MATLAB code for TWDP

Proposed resolution for comment
#109

Comparison results

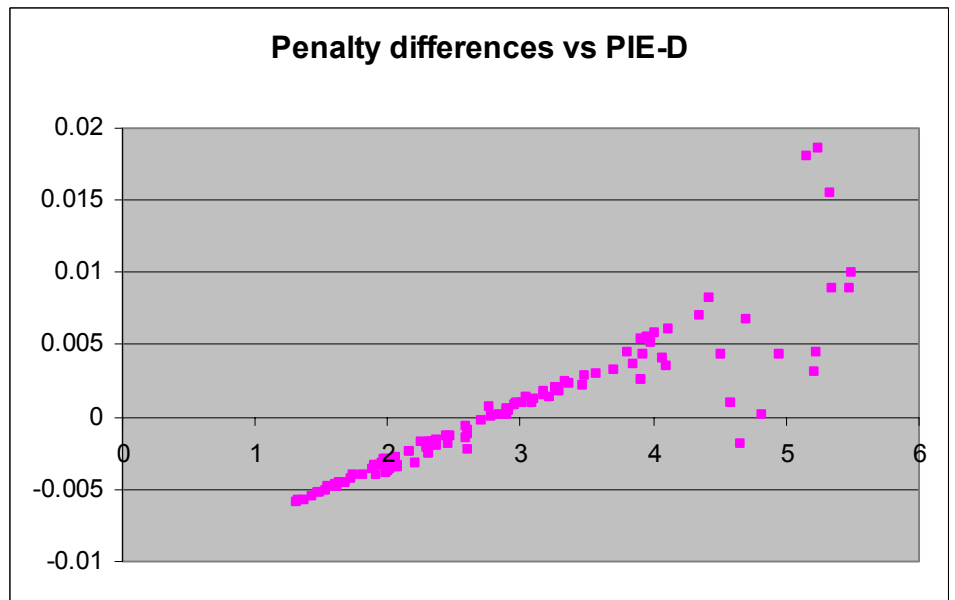
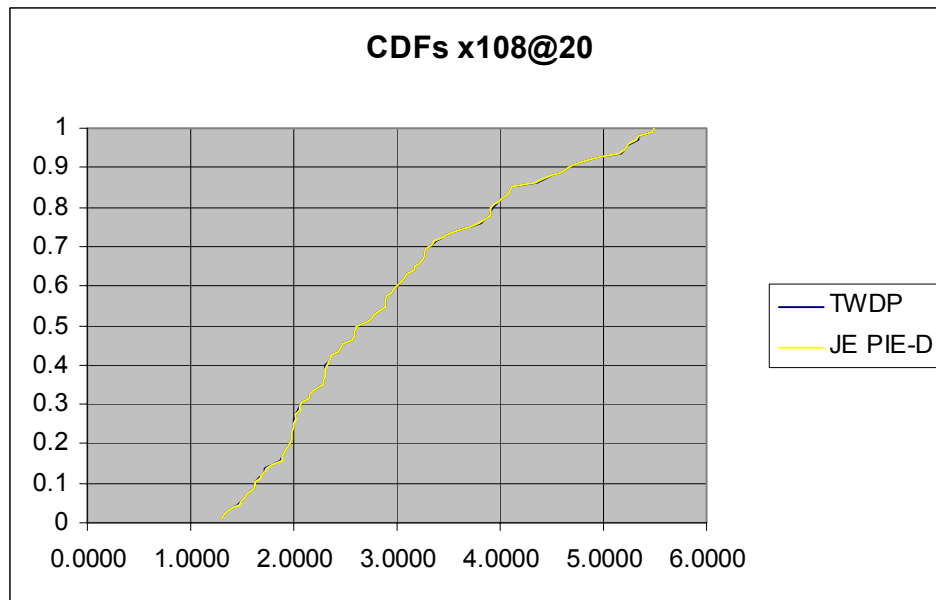
- CDF comparison of code to John Ewen PIE-D data
- Comparison based on
 - 47.1 psec 20-80% Gaussian prbs9 simulated waveform
 - 7.5 GHz BT4 filter on capture
 - Cambridge r2.1 (108 comparisons)
 - 20 micron fixed offset launch
 - No connectors

Within 0.02 dB; negative differences possibly explained by round-off errors in PIE-D, simulated waveform, or elsewhere.
